Section 16 Planning Application No. A/NE-MKT/47

Response to Departmental Comments Table

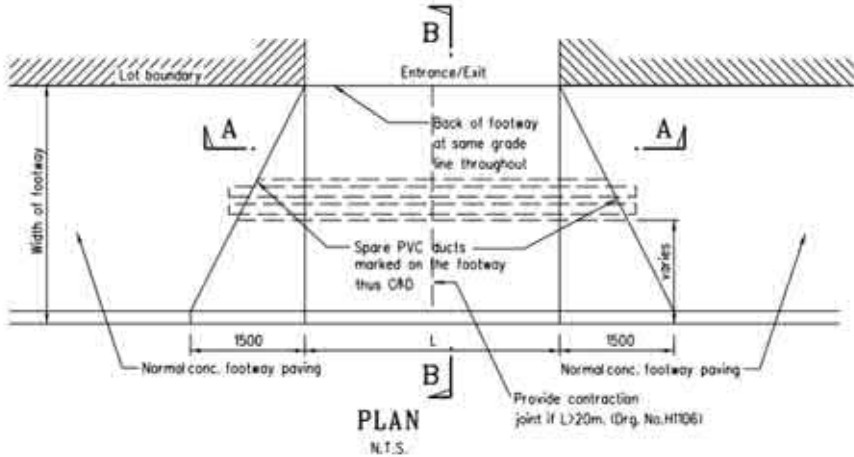
B. Commissioner for Transport (Contact Person: Mr. Eric TAM, Tel: 2399 2405)		
	Please note our comments on the subject application below from a traffic engineering point of view: (i) The applicant should provide a proposal and advise its adequacy on the vehicular access arrangement including the run-in/out design for the vehicles leaving/entering the proposed use;	Noted with thanks. The run-in/out of application site will not be smaller than 7.3m with reference to the guideline of Transport Planning & Design Manual in 2023. A set of kerb will be also erected to fulfill the requirement for footway crossing for vehicle entrance. The applicant will submit the proposal and seek comment from Transport Department and Highway Department upon receiving the approval of the application from the Town Planning Board.

No.	Comments Received	Our Responses
		<div data-bbox="1160 284 2011 742"></div> <p data-bbox="1160 746 2018 815">(Drawing H1113C retrieved from Highways Department Standard Drawings as at 26 June 2025)</p> <p data-bbox="1160 858 2029 1038">Swept path analysis is also conducted in Figure 2a-2d for the vehicular accesses and the proposed access road with references to Drawing H1113C and Drawing H1114B from latest Section 1 of Highways Department Standard Drawings, indicating sufficient turning spaces for goods vehicles.</p> <p data-bbox="1160 1078 2029 1259">In addition, “STOP AND GIVE WAY” and “BEWARE OF PEDESTRIANS” signs will be set at the run-in/out, whenever vehicles are to be accessed to / exit from the Application Site. The above measures will be implemented and maintained upon approval of the application.</p>
